Archives and Microfilm Dept 3022 West Wilden Avenue Goshen, Indiana 46528

02. Archives Parking lot

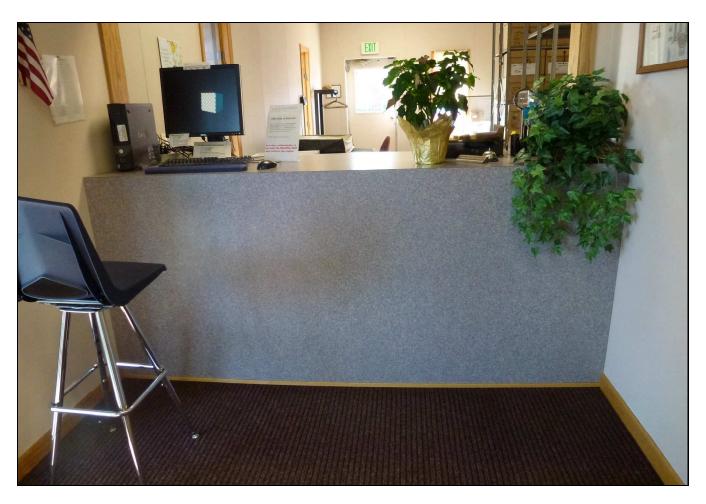
| Location | | Structural Inconsistencies | | Recommended Corrections/Modifications Technica to Provide Access | | I Information | | Finalized Actions | | | |
|----------------------------|-------|---|------------------------|---|---|---------------------|--------------------------------------|---|------------------------|-----------------------|--|
| 2. Parking | | No "Van Accessible" sign at van accessible parking space. No enforcement procedure for accessible parking | 4.6.4 | ADAAG requires accessible parking spaces to be located in each parking lot. Accessible parking spaces are required to have upright signage that incluces the symbol of a accessibility and van accessible signage where required. Add one "Van Accessible" sign. Enforce parking regulations. | H: This will be completed when the spot is added. | \$125 | Elkhart County General Fund | Added Van Accessible sign. | | Aug-14 | |
